Virginia Board of Housing and Community Development
CODE AND STANDARDS COMMITTEE
2018 CODE CHANGE CYCLE – BOOK 2
September 16, 2019

Tab 2 – USBC Proposals Recommended by Workgroups as Consensus for Approval

**FIGURE R802.4.5
BRACED RAFTER CONSTRUCTION**

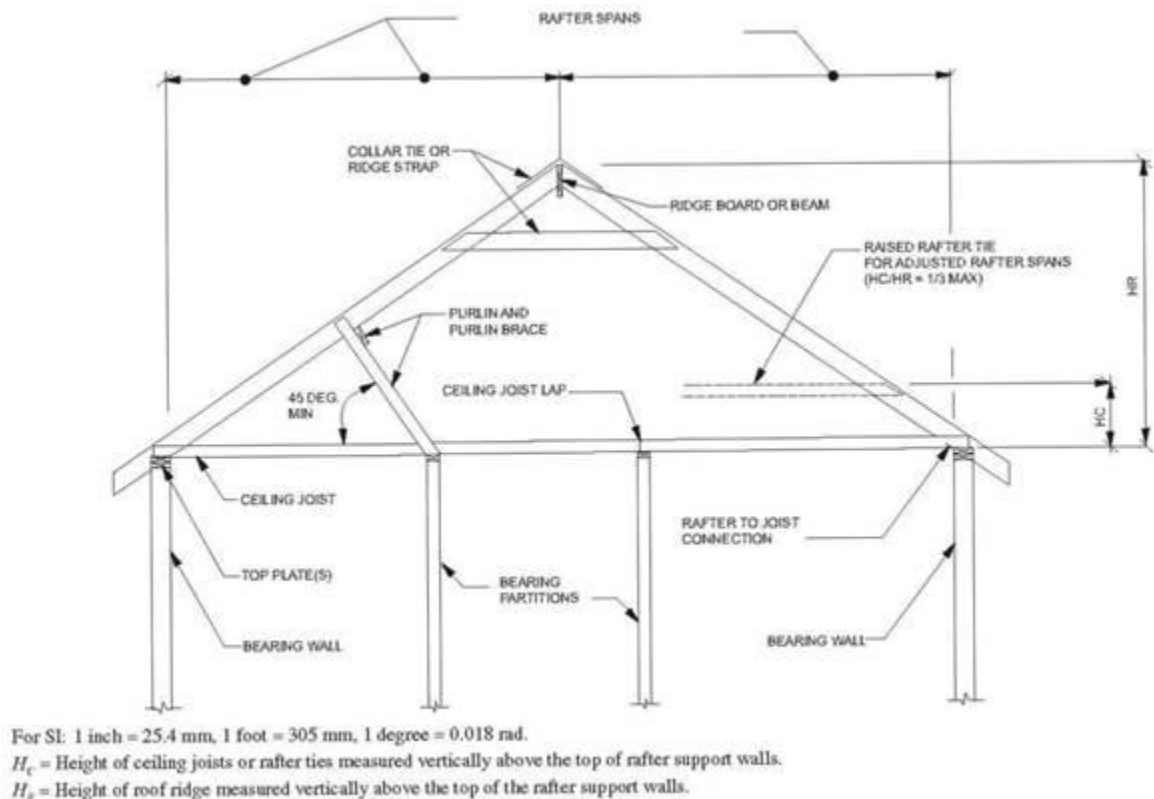
~~59. Add Figure R802.4.5 to read:~~

**Figure AQ104.1.3
Loft Ceiling Height**

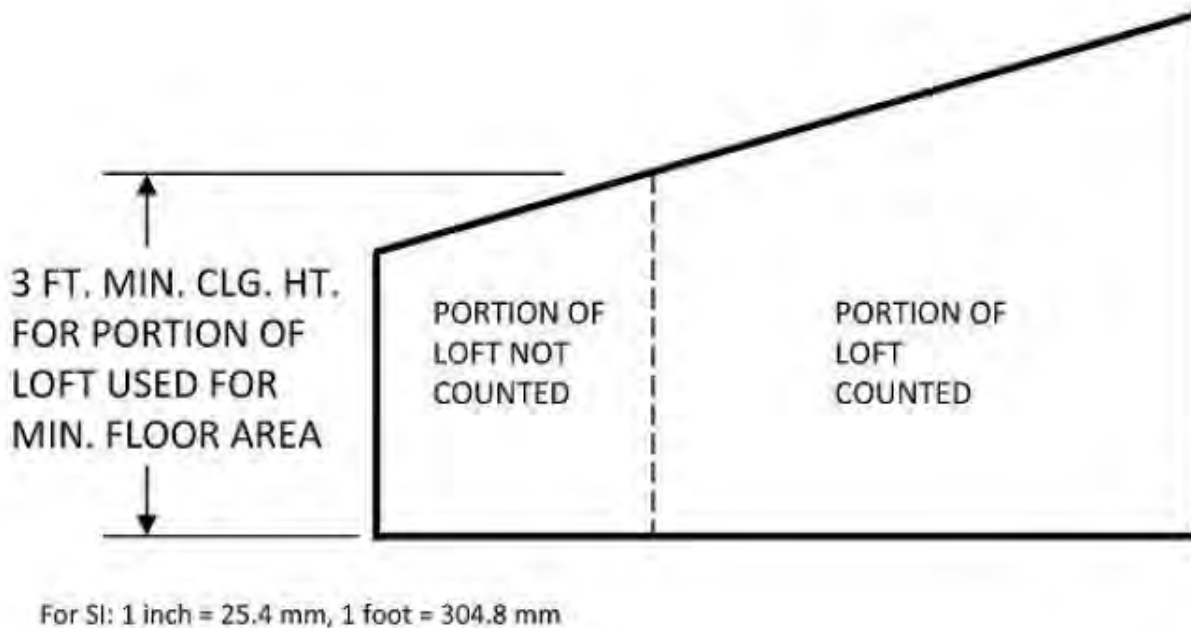
Add new text as follows:

Reason Statement: (Copied from proposal #218, this version is virtually the same, but with legislative formatting)
This proposal improves Appendix Q by 1) modifying the language in some sections to provide clarity, 2) adding Figure AQ104.1.3 from the Commentary to illustrate the meaning of "height effect, and 3) making other changes to the following sections:
